AGENDA BRIEF

MEETING: Town Council - 05 Jul 2022 **FROM:** James Dickhoff, Planning Director

PROJECT: Workforce Housing Project Site Selection

Site 1 – Aspen Village, Block 5, Lots 1 & 5, Block 6, Lots 2 & 3 (Rock Rd. & Boulder Dr.)

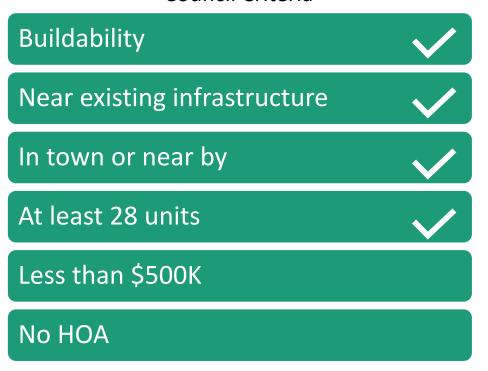
- 1. Aspen Village is a relatively new mixed-use subdivision with all the utilities available, and some service stub-outs, however, it is likely that a direct connection to the water line(s) will need to be made for building fire lines. For Block 5, Lots 1 & 5 it will require cutting across Rock Road.

- 2. Aspen Village has sidewalks and bike lanes throughout.
- 3. Will likely need to cut out curb and gutter and install driveway cuts to work with specific site design.

- 4. A storm drain system exists in this portion of Aspen Village to convey runoff to the regional detention pond. Based on the site design, the peak runoff will need to be evaluated to see if the storm drain has the capacity to convey the runoff, and if not, detention ponds may be required to mitigate the peak on-site.

- 5. The sites are generally level and can be fully utilized and were manipulated during subdivision construction to obtain the current configuration. Geotechnical evaluation should be performed to verify the soil condition and to provide construction recommendations.

- 6. Being a new subdivision, and the anticipated lack of bedrock, it is not envisioned that significant additional site development cost will be necessary.

- These lots appear to be ready for construction with little or no main line infrastructure extension improvements.
- Walkable to grocery, retail and services.
- A portion of Lot 1 of block 5 is adjacent to Aspen Village Drive a high traffic roadway, which
 may not be ideal for residential units, however buffering could be included to reduce noise
 impacts. The remaining lots have little exposure to high traffic.
- The properties are zoned MU-C, allowing up to 16 units per acre, prior to a density bonus.

Site 2 TOPS Piedra Business Park

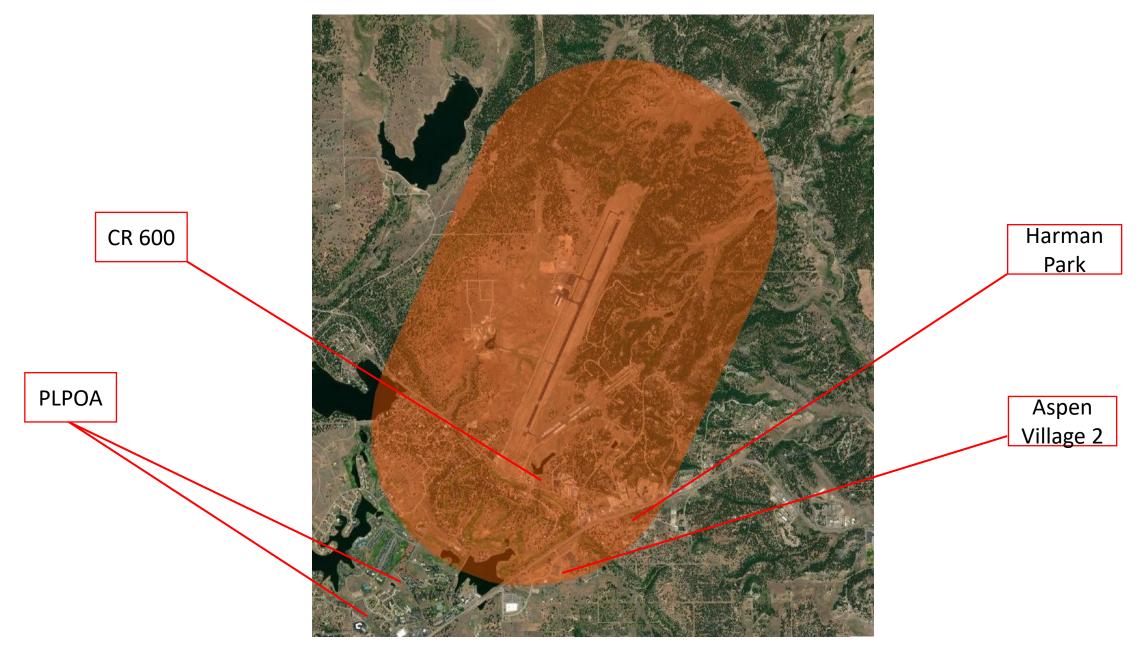
- 1. A 6-inch water line and 8-inch sewer line run through the property generally between the lots. The PAWSD map shows the water line to be on the back side of a master meter, so it should be confirmed that it is a public line.

- 2. Dry utilities are in the vicinity and may need to be extended to some degree to the site.
- 3. Stevens Lake is located just to the north of the subject lots, and we believe it is a jurisdictional dam under the purview of the Colorado Division of Water Resources, Dam Safety Division. The outlet from the lake runs through the lots in some fashion. The outlet used to drain into a canyon that was located on the north side of Piedra Road. This canyon was filled in several years ago, and a culvert extended from the outlet pipe to the culvert that ran under Piedra Road. In reviewing this culvert several years ago, it was rusted out for the portion under the road. Site drainage will need to be mitigated, and then conveyed to this pipe.

- 4. It is anticipated that bedrock is very close to the ground surface throughout the lots. It was noticed that it appeared one of the utility lines (water or sewer?) had earth mounded over the top.

- 5. While the sites are fairly level, due to the bedrock, it is likely that significant import fill will be needed to develop the site.
- 6. Vehicle access will likely need to come from Wildwood Circle or Backswing Court, as appropriate. Arrangements will need to be made with the owners of these roads as necessary.

- 7. There are no pedestrian handling amenities close to the project.

- These lots have a number of potential challenges including non-compacted fill, deteriorated underground culverts, and access agreements and improvements.
- These lots are not in a walkable area.

Site 3 – Harman Park, Lots H1, H2, H3, H4X, and H6X (Papoose Court)

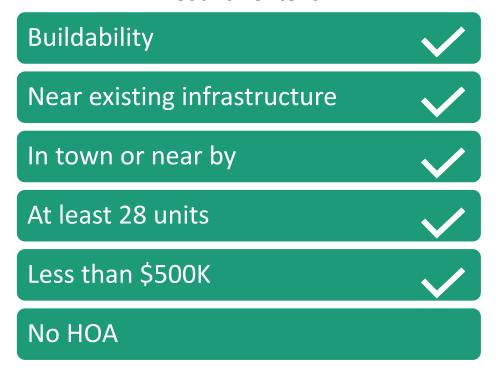
- 1. Harman Park is a relatively new mixed-use subdivision with all the utilities available, and some service stub-outs.
- 2. The sewer for the subdivision is a private high-pressure low flow system that requires individual lift stations for each site/project. During work on other projects in the subdivision, it sounded from discussions with Ambiente H2O, the consultant/supplier that works with the sewer owner and is intimately familiar with the system, that the existing pressure sewer system may be nearing its capacity. Rectifying this may require replacing the main force main line, potentially up to 2,000 feet long all the way to the TOPS sewer on Eagle Drive.

- 3. Harman Park has sidewalks in the immediate vicinity of the subject lots.
- 4. Will likely need to cut out curb and gutter and install driveway cuts to work with specific site design. If all the lots are obtained, it may be desirable to remove Papoose Court entirely to better utilize the overall area.

- 5. If Papoose Court remains, it will likely need to be cut for building fire line connections.
- 6. There is a regional detention pond for Harman Park, but it is not clear how it is to function. As such, it may be necessary to have on-site runoff mitigation with a detention pond.

- 7. The lots have a moderate slope downward from west to east. There is bedrock close to the surface throughout the subject lots, and because of this, significant import fill may be necessary to develop the site.

- The bedrock in Harman Park is very close to the surface.
- The Harman Park private pressured sanitation collection system appears to be very close to maximum capacity, requiring a substantial improvement investment.
- Could purchase all lots and vacate Papoose Court providing additional land to accommodate the development (parking / access).
- Not an ideal location based on the above considerations.

<u>Site 5 – Central Core, Lot 4-B and Lot 4-AX (Eaton Drive)</u>

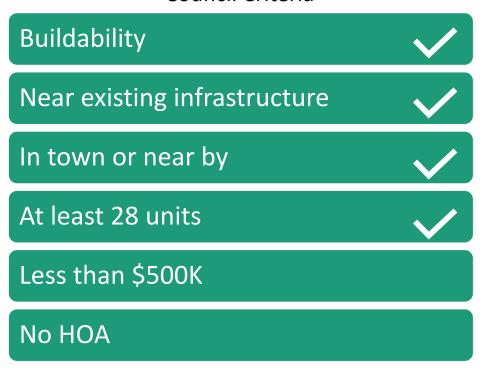
- 1. An 8-inch water line runs along Eaton Drive, and an 8-inch sewer line runs along the southwesterly lot line, with a 6-inch sewer line running between the two lots.

- 2. Dry utilities are in the vicinity and may need to be extended to some degree to the site.
- 3. There is a natural drainage through Lot 4-AX that conveys the runoff from Whispering Pines 10 that will need to be maintained. This drainage may be a good location for a detention pond (provided there are no wetlands present) to mitigate on-site runoff peak flows, which then can discharge to the natural drainage to the southwest.

- 4. Lot 4-B can be fully utilized, while Lot 4-AX can be significantly used except for the above-mentioned drainage.
- 5. The Park Avenue multi-use trail goes along the northwesterly property line. There is also a sidewalk across the street along Eaton Drive.

- 6. There is a fire access easement for apartment complex to the south that will need to be incorporated into the design for any project on Lot 4-AX.

- These lots provide an opportunity to accommodate our current housing project, but also to land bank to help accommodate future housing projects.
- Very walkable to grocery, retail, services, and medical.

- Lots are within Town Boundaries, and within PLPOA HOA boundaries.
- Though the lots are within PLPOA requiring a current \$275/year HOA fee (\$25/month estimating a future increase to \$300/year), these fees provide HOA residents with access to open spaces, lakes and low annual fee recreation center passes. In addition, a portion of the HOA fees are applied to trail development projects throughout PLPOA, which ultimately interface with the Town's trail system. PLPOA has previously participated in Trail development along Village Drive and had offered to participate in the future N. Pagosa Blvd trail connection to Hwy 160.

- Lot 4-B is only available with the purchase of Lot 4AX.
- These lots could provide the opportunity to continue additional future workforce housing development phases.

- Town R-12 zoning. PLPOA PUD for multi-family would allow up to 15 units per acre. Lot 4AX 3.77 acres = 57 units. Lot 4-B 4.06 = 61 units. Total potential 118 units.

Site 8 - Citizens Plaza, Lot C (Talisman Drive and Village Drive)

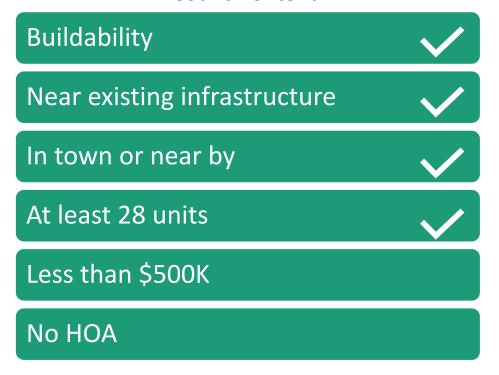
- 1. A 6-inch water line runs along the east properly line, and an 8-inch sewer line along both Talisman Drive and Village Drive.
- 2. Dry utilities are in the vicinity and may need to be extended to some degree to the site.

- 3. There is a natural drainage system along the west property line (Talisman Drive) that will need to be maintained and likely has wetlands along it. The lot can be utilized all but whatever is covered by wetlands.

- 4. The lot has a fair amount of elevation difference, with 15 to 20 feet of fall from the southeast corner to the northwest corner.
- 5. Half of the parking lot to the south is on the subject parcel. The asphalt is in poor shape with several potholes. Also, the parking quantity appears to be insufficient for the neighboring property, as there were several cars double parked or parked along the edge of the parking lot (on the subject property).

- 6. The Village Drive multi-use trail crosses the property at the northwest corner.

- Residential is not the highest and best use of this site with commercial uses on each of the other three corners of this intersection.
- Wetlands compromise full use of site.
- MU-TC Zoning would allow up to 24 units, prior to a density bonus.
